**PLANNING & ZONING BOARD
AGENDA ITEM 7A**

REQUEST: **PUBLIC HEARING**
Conditional Use Permit for Open and Outdoor
Storage for Bald Eagle Erectors (7309 Lake Drive)

Re: *Bald Eagle Erectors
Plan Review
WSB Project No. 2988-480*

To: Katie Larsen
From: Marty Asleson
Date: February 03, 2017
Re: Bald Eagle Erectors/Environmental Staff Comments

C2.0

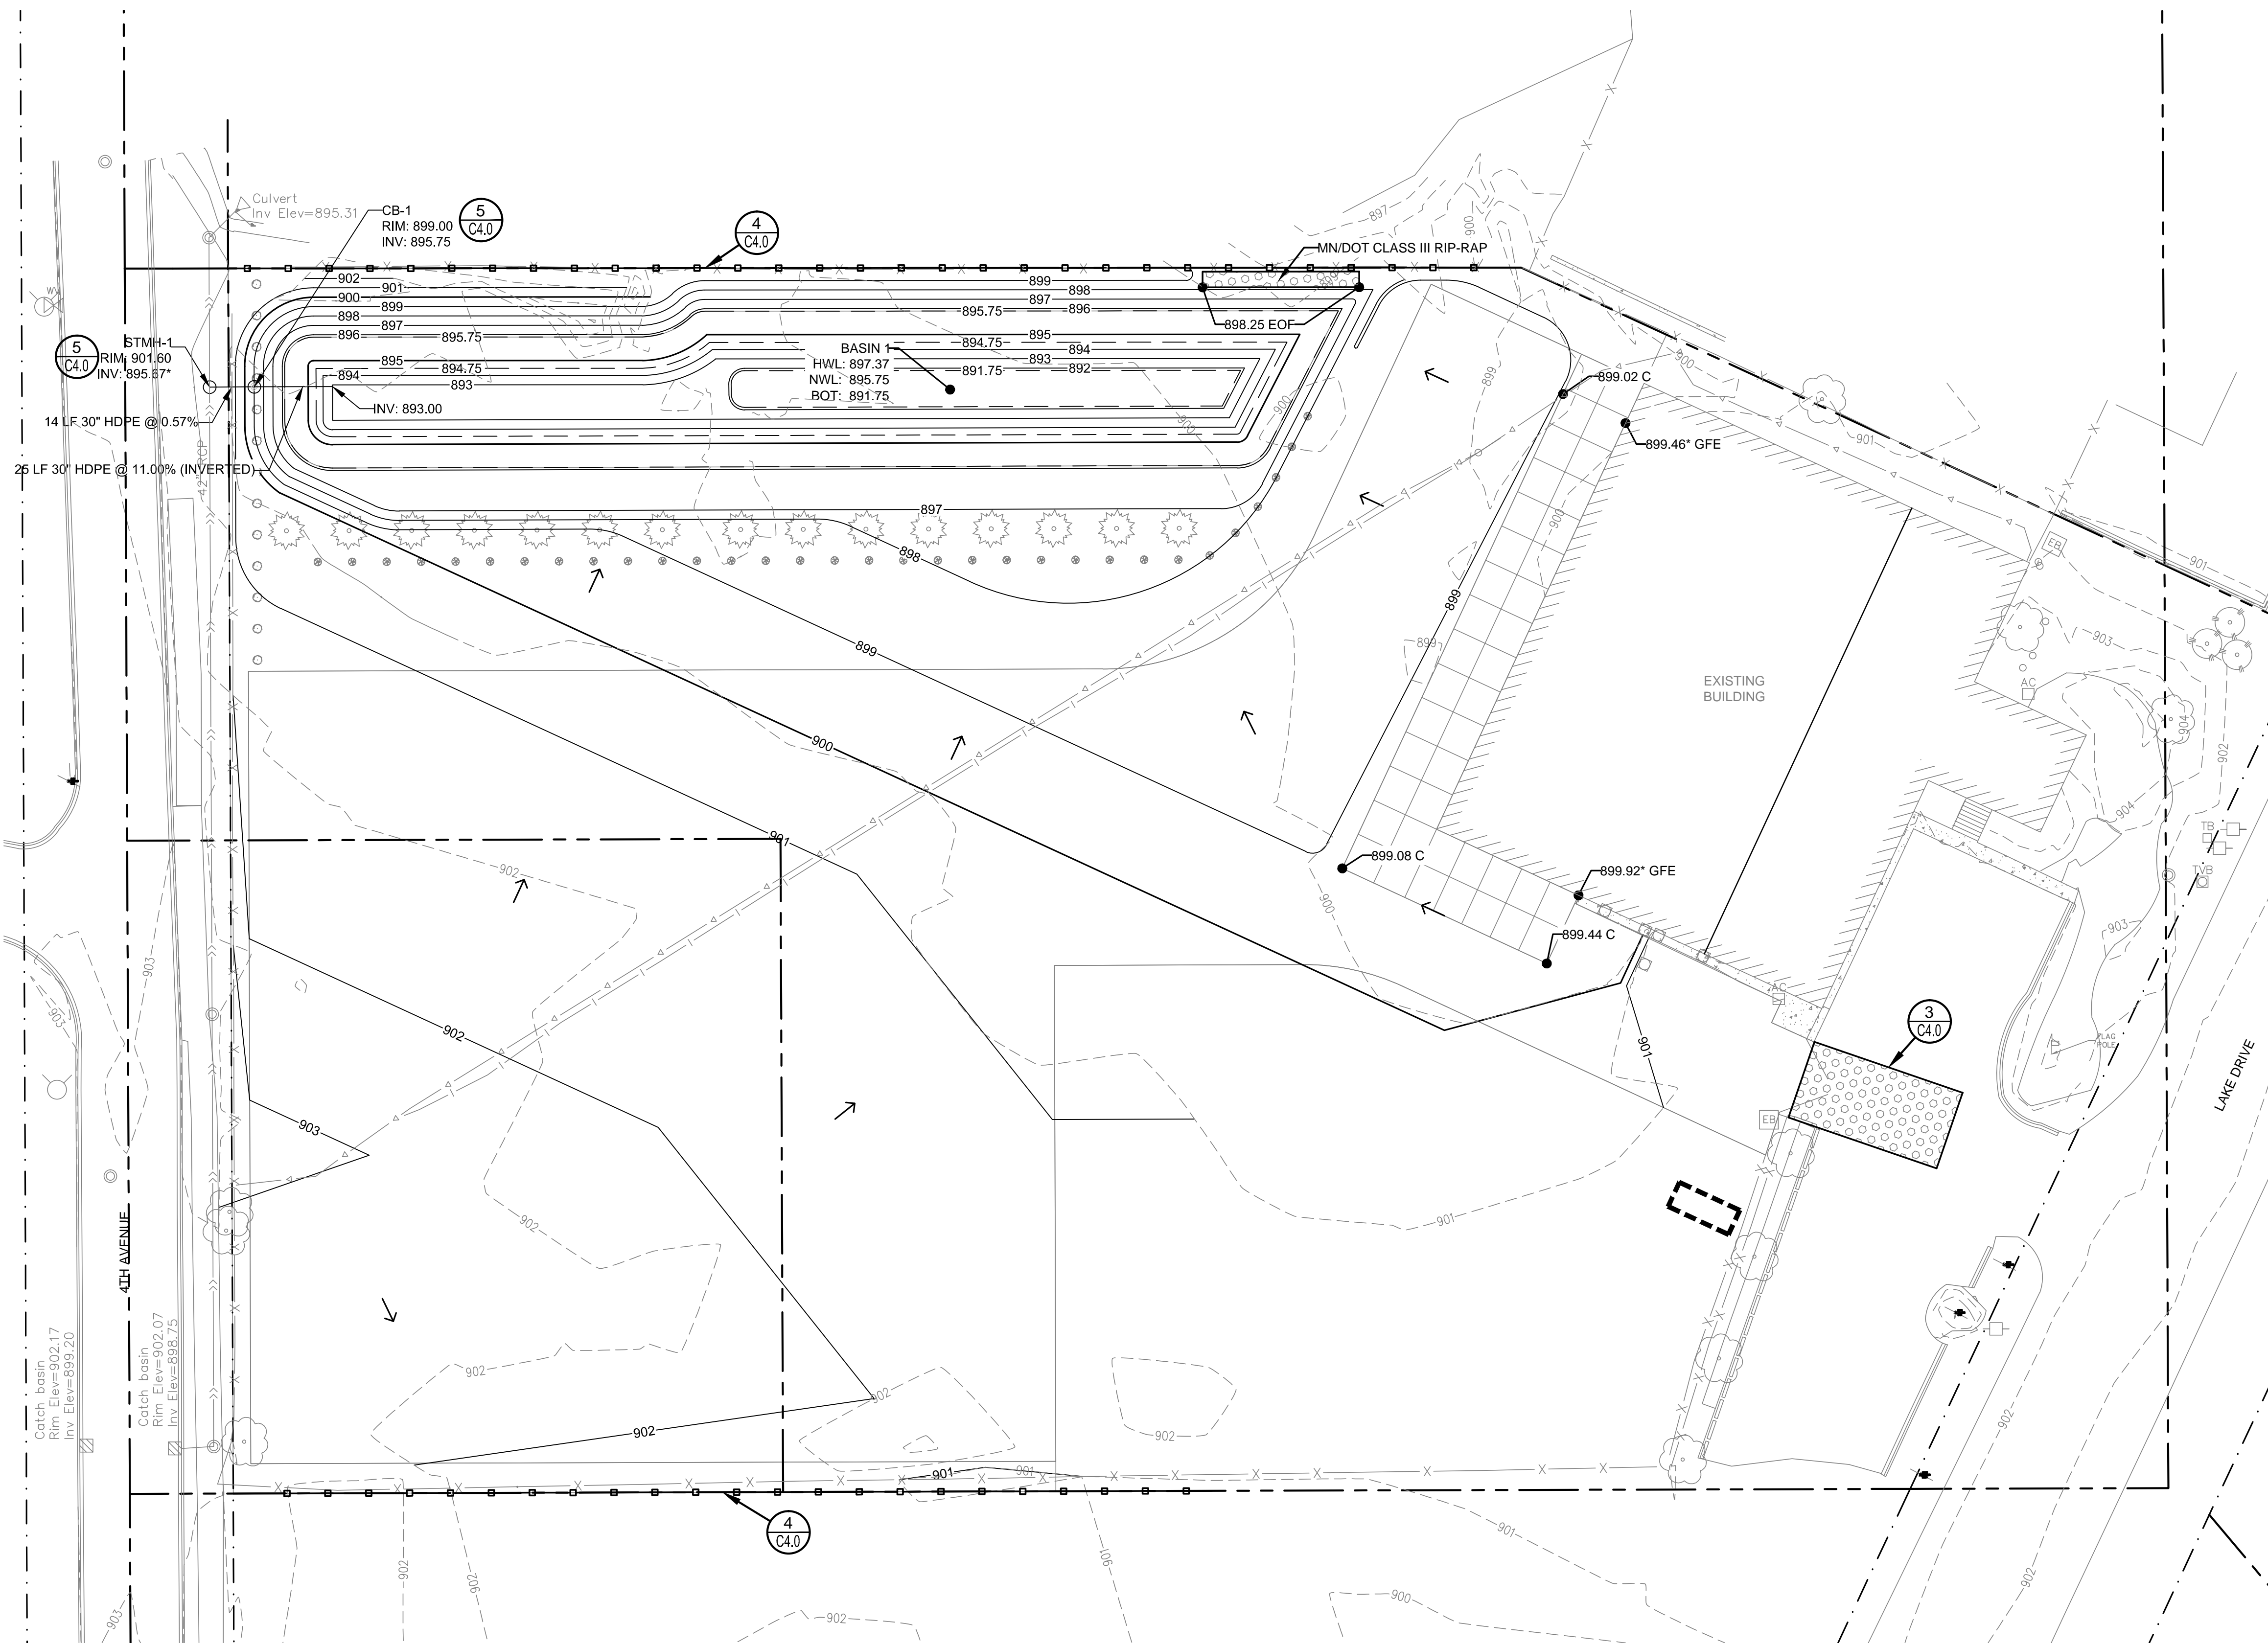
area. Per section 1007.043 (17) (e) requires 1 large tree and 3 large shrubs per 2000 sq ft. Per plan sheet C2.0 the applicant is proposing 15 large trees and 45 large shrubs.

The open and outdoor storage meets impervious and surface coverage. Per plan sheet C2.0, the site is 5.45 acres and allows for a maximum of 75% impervious surface cover. The proposed plan indicates an impervious surface coverage of 3.14 acres or 57.6%.

7. Distance between south and west lot line and edge of storage area shall be shown on plan sheet C2.0.
8. Storage area to building ratio shall be shown on plan sheet C2.0.

- Native shrubs should be used for the proposed shrubs. Red twig dogwood and yellow twig dogwood would be a good substitute.
- The Techney Arborvitae along 4th avenue, if this is a screening requirement should be mulched in, and separated in the landscape from the native prairie plants. If there is a need for 100 % screening at the finish of construction, more plants will be needed.

C3.0

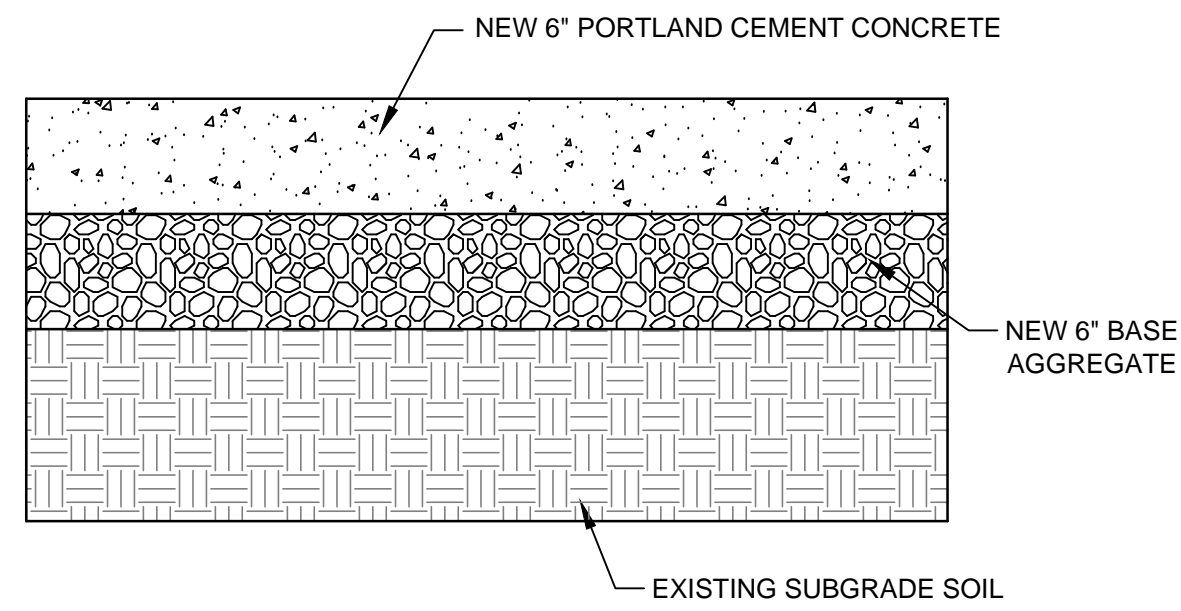
8. Geotextile blanket required under proposed rip rap at EOF.
9. Label pond side slopes (3:1 max.), minimum 10 foot safety bench.

1. The applicant shall demonstrate that the site drainage via sheet flow is sufficient to drain the site with the proposed use of storage containers. Label the percent grades within the proposed paved storage/drainage area. Storm sewer and curb and gutter may be required is sheet flow would result in puddling for the one inch rainfall event.
2. There is a discrepancy between areas shown on Sheet C2.0 and areas used in the HydroCAD model.
3. Invert elevation shown on Sheet C3.0 for the primary outlet is different than what was used in the HydroCAD model.
